Ground Water Science

September 13, 2007

Re: Review and recommendations for Ft. Bowie NHS water supply well

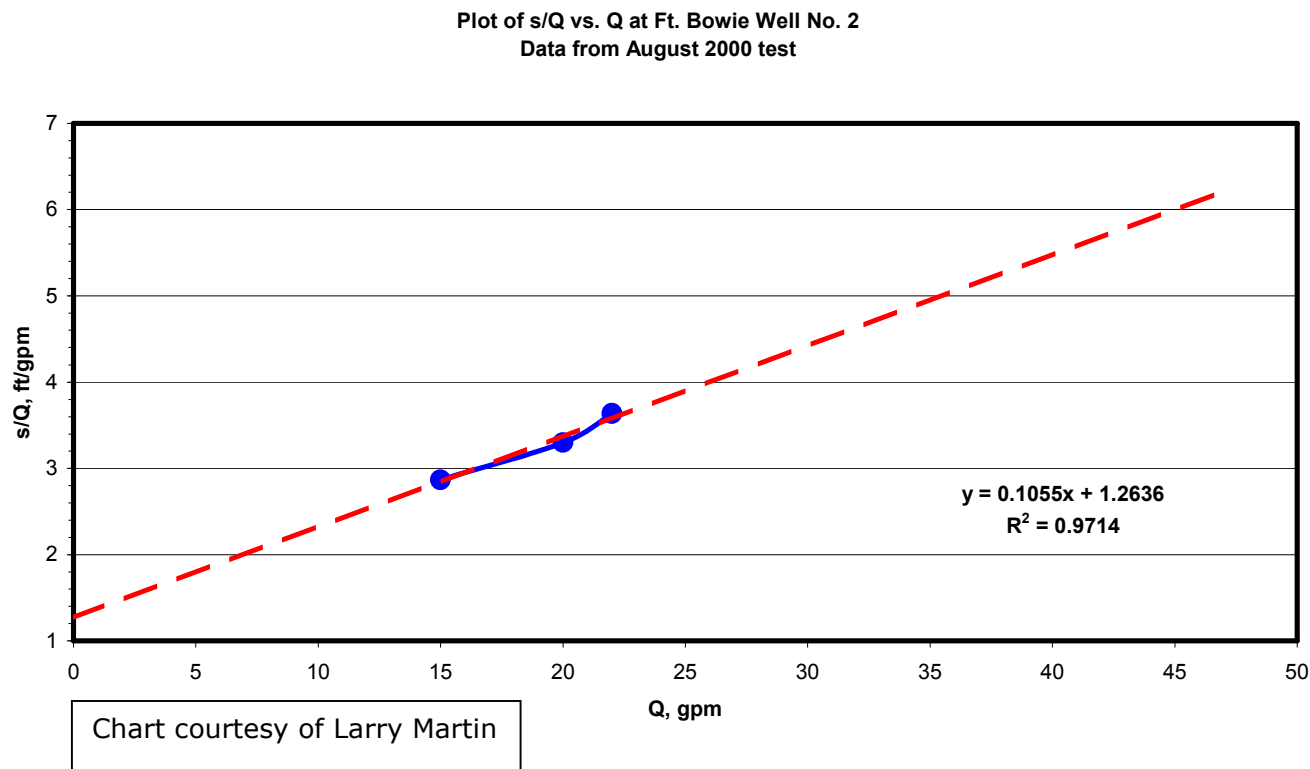
The inverse of Q/s (s/Q) is used in graphical analysis of step-drawdown pumping tests (Krusemann and de Ridder, 1994). These were not from a pro forma step test, but as the plot on the following page illustrates, they plot reasonably well on a straight line, typical of valid step test results. Using this plot, a y-axis intercept (B) can be estimated and used in the formula BQ/s to yield a well efficiency value (E_w) as shown above. This serves in the absence of calibrating values from an aquifer test.

All the values for 10 gpm were extrapolated for illustration and the $s = 230$ for $Q = 40$ gpm also estimated. The $s = 140$ ft for 40 gpm was that measured, but it is clear that it was far from being a stable PWL. Extrapolation from analysis indicates that the original 40-gpm s would exceed total well depth (about 230 ft).

In water well design, efficiencies below 70-80 % are considered poor. The other thing to note is that the Q/s values are very poor, such that drawdown is excessive. Consequently the s/Q values are very high, indicating either poor contact with the formation or very low water zone transmissivity (T). This well has been hydraulically inefficient from the beginning and began life with steep drawdown performance.

Summary chart of performance projections assuming calculated well efficiency and flow rates

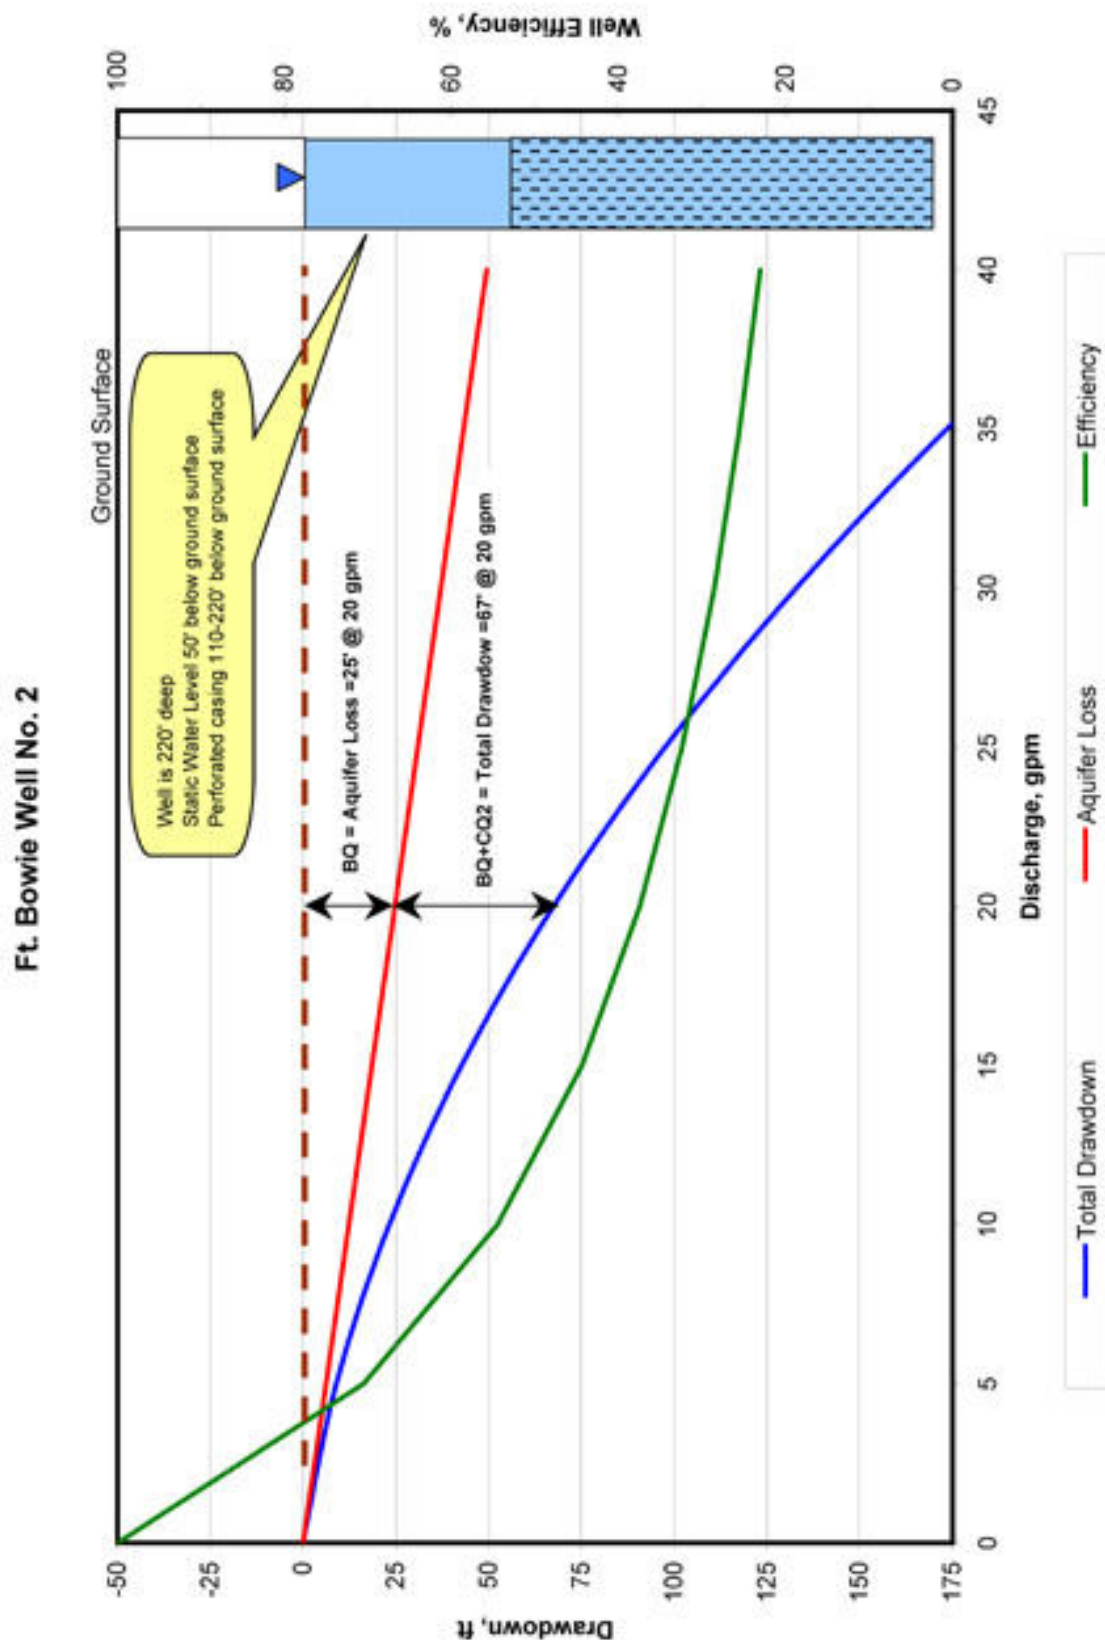
The well then was allowed to sit idle until equipped with a pump (3 HP, 25 gpm) and brought on line in February 2002. This pumping choice resulted in a system capable of drawing the PWL below the top of the slotted interval (below 110 ft), exposing these to aeration. Note also from the table that at 25 gpm, *new well* efficiency is below 35 % -- about one-half that considered acceptable in good well design and development.

- 1) Continue throttling the well to about 10 gpm output minimizes drawdown and oxidation in the slotted zone and is a good short term way to "buy time" until further treatment can be budgeted and scheduled. This output is sufficient for the water demand. At the time of construction, efficiency was probably ~ 53 % at 10 gpm. It is likely lower now.
